ATAS INTERNATIONAL, INC 610-395-8445 Mesa AZ

Denaline Existing Jamb Window Detail

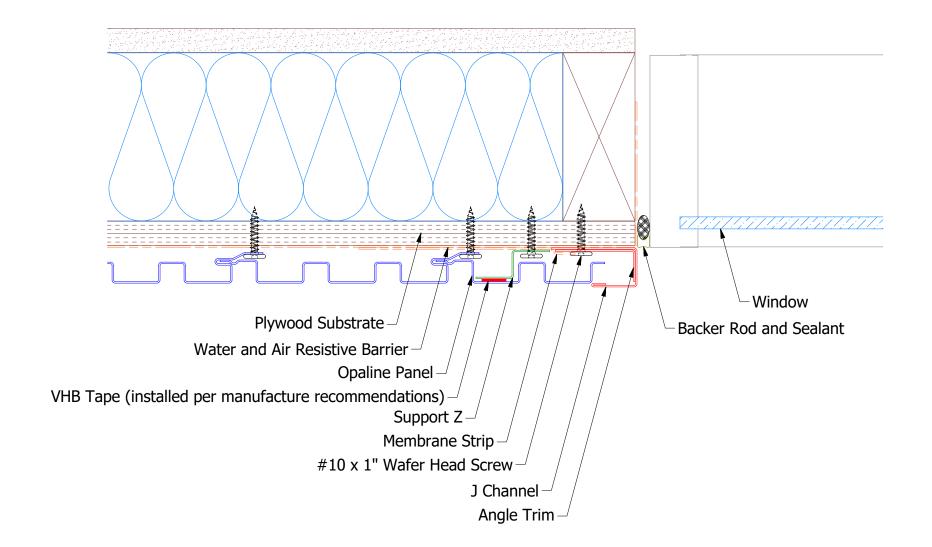
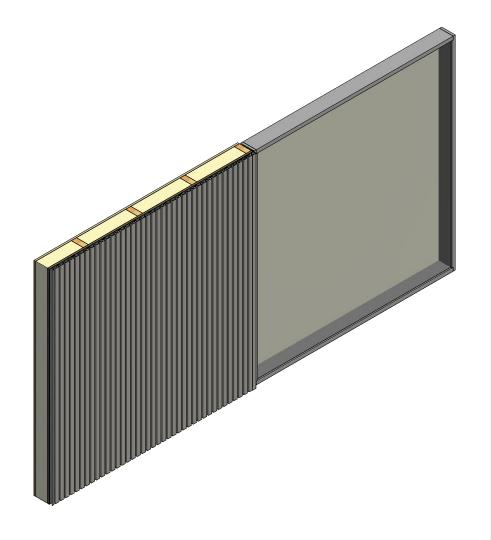
117
					C
					DWG
)1	8/30/2021	Changed Pop Rivets to VHB Tape	KRK		MATE
EV.	DATE	DESCRIPTION OF REVISION	BY	APP

Note: stainless steel pop rivets maybe needed along with VHB tape for longer panels.
